## TECHNICAL SERVICE BULLETIN

### Vehicles Equipped With A 2.0L (Panther) Engine – Rattle Type Noise From The Transmission Area At Light Accelerator Input

23-2263

This bulletin supersedes 23-2211. Reason for update: Incorrect Procedure

Figure 1

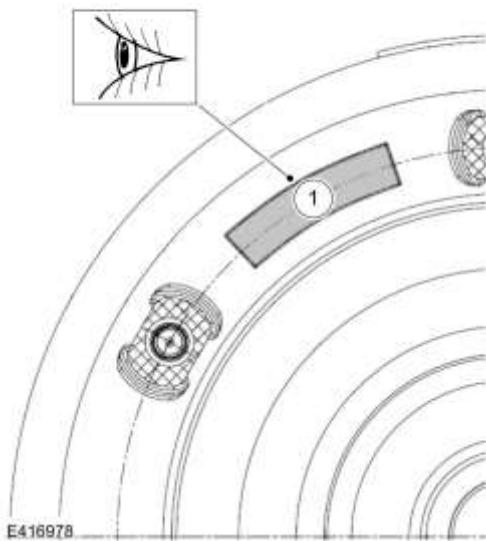
7. Remove the transmission and verify the torque converter part number Prefix and Suffix. Ensure the torque converter part number is JB3P-(7902)-JD or later. If the part number is JB3P-(7902)-JC or earlier, then replace the part with a new torque converter (JD or later). (Figure 1)

Callout 1: Ford Part Number Prefix and Suffix 3mm Max High Here
